## STAFF REPORT

### Community Planning and Preservation Commission Certificate of Appropriateness Request

**AGENDA ITEM:** CITY FILE NO.: 20-90200119

**REQUEST:** Review of an After-the-Fact Certificate of Appropriateness for window replacement at 812 8<sup>th</sup> Ave. S., a contributing property to the Roser Park Local Historic District (87-01)

Window Placement  
812 8th Ave S.  
Garage

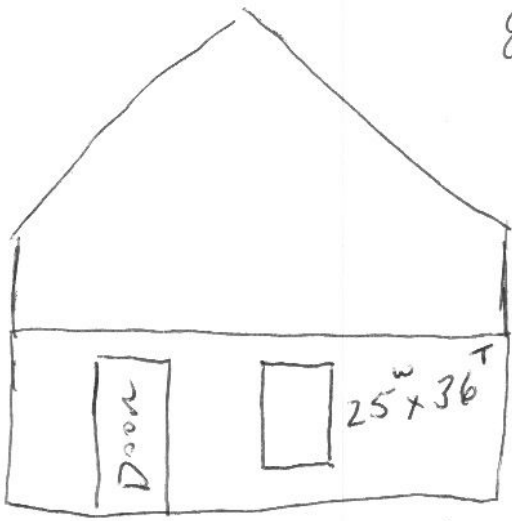
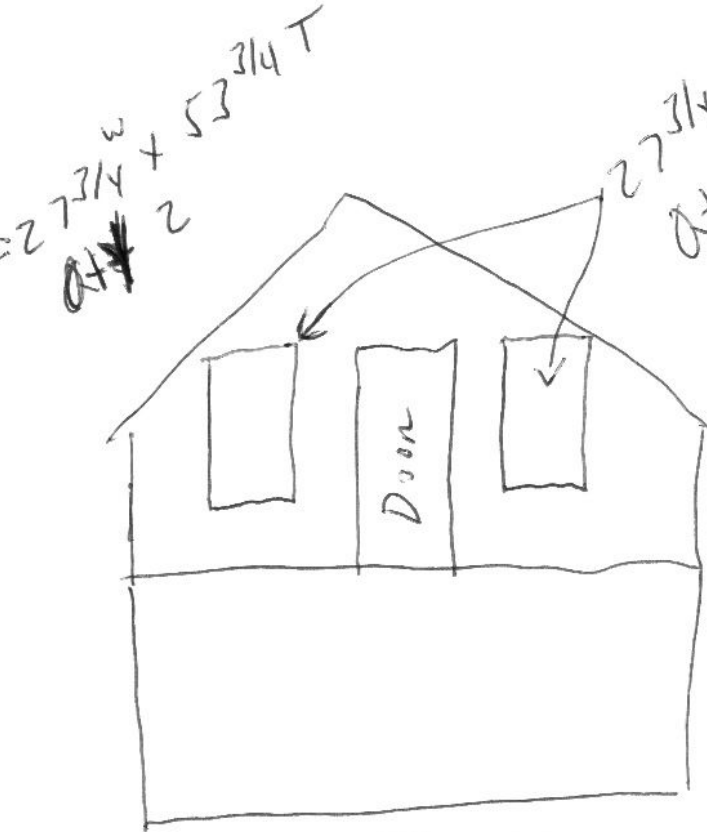
**Inconsistent** The windows at the garage building, like those at the primary residence, have been installed approximately flush with the exterior wall plane, with depth added by trim applied around the opening. This was a point of discussion during the after-the-fact COA for the installation of windows at the main residence, with.

**Consistent** The sizes of the replacement windows match existing openings.

**Consistent** Three-over-one sash windows are consistent with those observed at the property historically.

Staff recommends approval of the windows that have already been installed at the garage apartment with their existing reveal, but finds this case to exemplify the necessity of requiring that all replacement windows be installed with a traditional setback.

1. Replacement windows will be fitted with contoured, three-dimensional external muntins.
2. Wooden exterior casing and trim will be reinstalled in kind, and closely replicated where the historic material cannot be salvaged or reinstalled.
3. All other necessary permits shall be obtained. Any additional work shall be presented to staff for determination of the necessity of additional COA approval.
4. This approval will be valid for 24 months beginning on the date of revocation of the local Emergency Declaration.
5. A historic preservation final inspection will be required.
